Response to Government Departments Comments on Application Number A/NE-TKP/1

Proposed Temporary Private Garden for a Period of 3 Years on Government Land Adjoining Lot No. 369 in D.D. 255

Water Supplies Department Additional Comments

Plan 1: Shows the current layout of the proposed site and indicates the existing concreted areas, tiled areas and grassed areas.

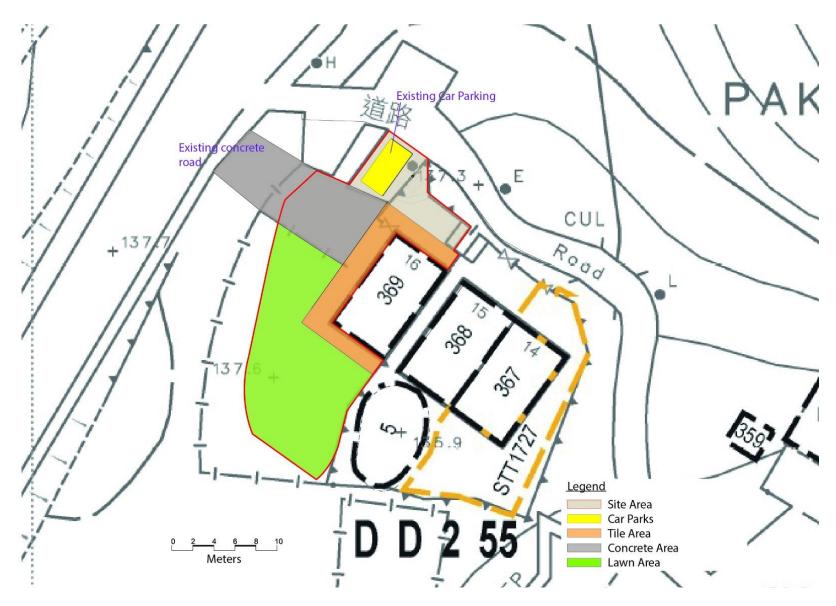
3.	Besides, the applicant shall show clearly the location of the existing and proposed garden in the map of the Site for review.	Annex 2 includes two plans which are to scale. Plan 1 shows the current layout of the proposed site and indicates the existing concreted areas, tiled areas and grassed areas.

Plan 2 shows the proposed garden layout, with the proposed grassed area and concreted area indicated (which would remain) as well as the location of the formation area for the proposed additional car park. The location of the sheds, the proposed tiled area and the covered area are also indicated.
